# UNITED STATES PATENT AND TRADEMARK OFFICE

APPLICATION NO.	FILING DATE	FIRST NAMED INVENTOR	ATTORNEY DOCKET NO.	CONFIRMATION NO.
09/936,078	11/13/2001	Bruno Colin	BONN-063	7937

<b>Office Action Summary</b>	Application No.	Applicant(s)	
	09/936,078	COLIN, BRUNO	
	Examiner	Art Unit	
	Jan M. Ludlow	1743

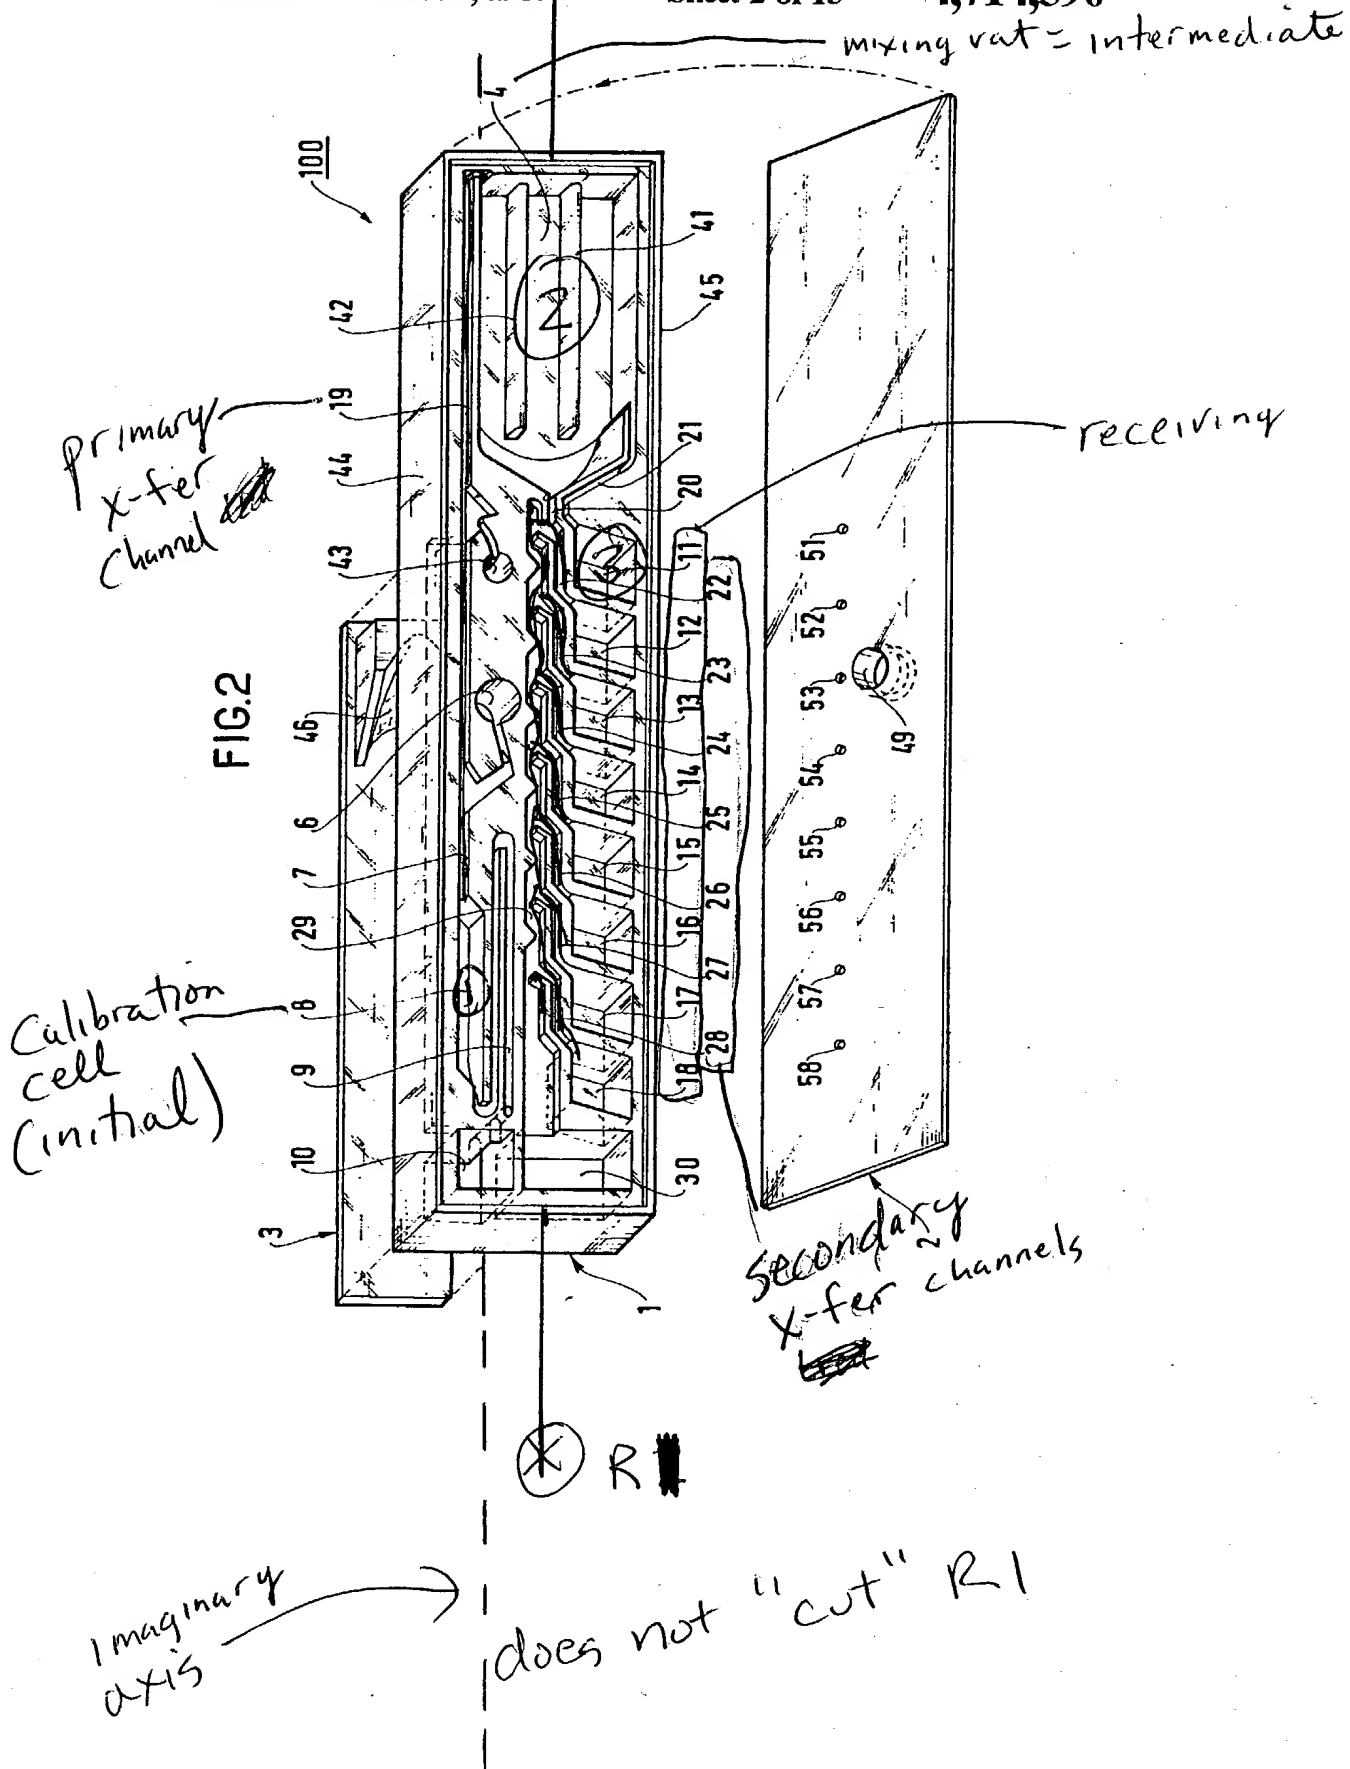
6. Claim 9 is rejected under 35 U.S.C. 102(b) as being anticipated by Guigan 4714590.

Guigan teaches providing fluid in a calibrated cell 8 (instant initial compartment), centrifuging to drive fluid into a mixing vat 4 (instant intermediate) via capillary duct 19 (primary transfer channel) using a first rotational axis distal from the mixing vat end of the device (lower end in Fig. 2), reversing the orientation of the device relative to the axis of rotation of the centrifuge to provide a second rotational axis adjacent the mixing vat end of the device (upper end in Fig. 2), and centrifuging to drive fluid from the mixing

chamber to a plurality of reaction vats 11-18 (receiving compartments) via a plurality of capillary ducts (second transfer channels). See, e.g., col. 1, line 30- col. 2, line 30 and Fig 2.

apparatus" in that an imaginary axis through the initial compartment (calibration cell 8) and the intermediate compartment (mixing vat 4) does not cut or intersect the first rotational axis distal from the mixing vat, i.e., when the mixing vat is positioned near the periphery of the centrifuge (near the lower end of the device as seen in Figure 2). A copy of annotated Fig. 2 is attached.
